This sheet transmits Revision 02 to Service Bulletin 190-22-0004.

AUTO FLIGHT - CAT IIIa AUTOLAND INSTALLATION

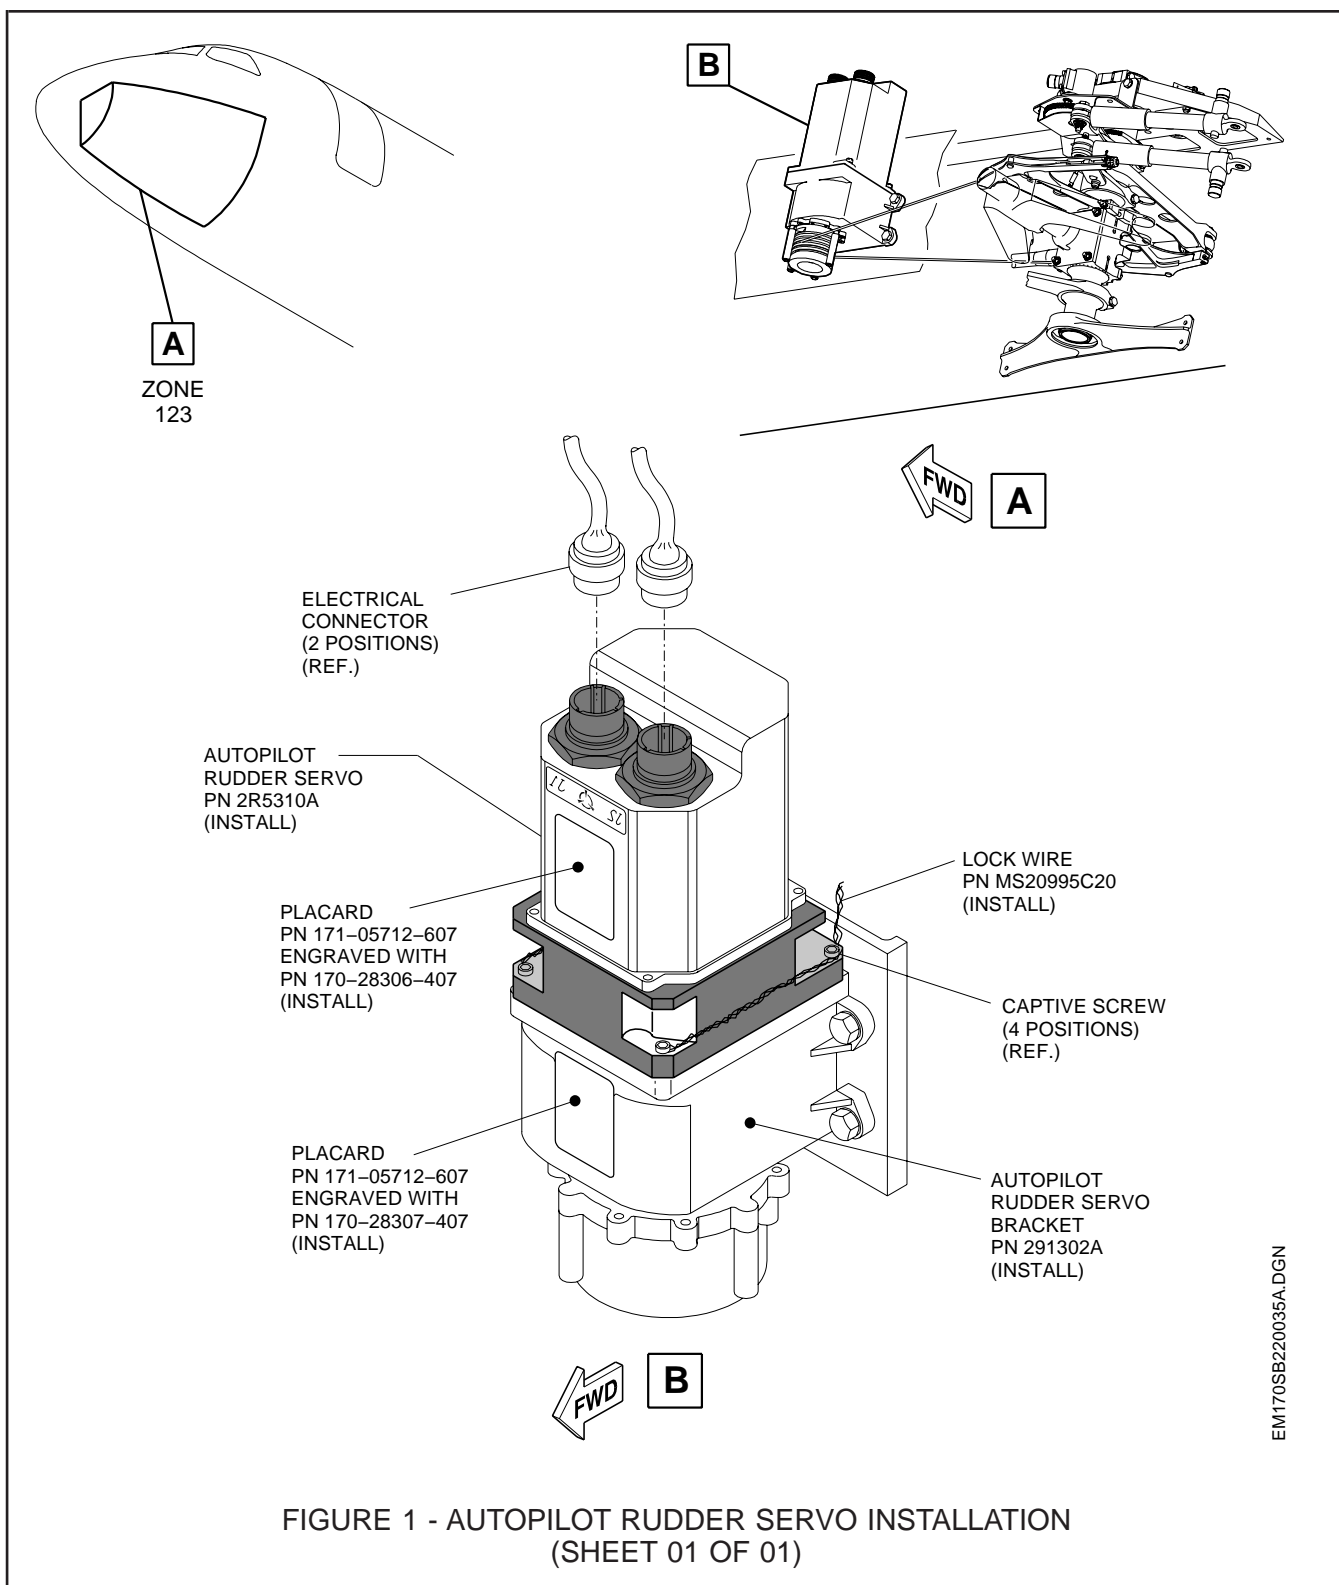
- (1) Install autopilot rudder servo bracket PN 291302A in conjunction with autopilot rudder servo PN 2R5310A in accordance with AMM TASK 22-11-06-400-802-A/400 - Autopilot Rudder-Servo Bracket - Installation. Refer to [Figure 1](#).

NOTE: To make the electrical connection, it is necessary to release the existing clamp which ties the electrical cable as a loop, connect the electrical connector (2 positions) to the autopilot rudder servo, and install clamp PN MS21919WDG6 in the place from which the used clamp was removed.

- (2) Install autopilot rudder cable PN 171-06712-401 and PN 170-03487-401 in accordance with AMM TASK 22-11-09-400-801-A/400 - Autopilot Rudder Cable - Installation.
- (3) Install placard PN 171-05712-607 on autopilot rudder servo bracket (identified with PN 170-28307-407) in accordance with AMM TASK 20-10-09-400-801-A/400 - Placards and Markings - Installation. Refer to [Figure 1](#).
- (4) Install placard PN 171-05712-607 on autopilot rudder servo (identified with PN 170-28306-407) in accordance with AMM TASK 20-10-09-400-801-A/400 - Placards and Markings - Installation. Refer to [Figure 1](#).
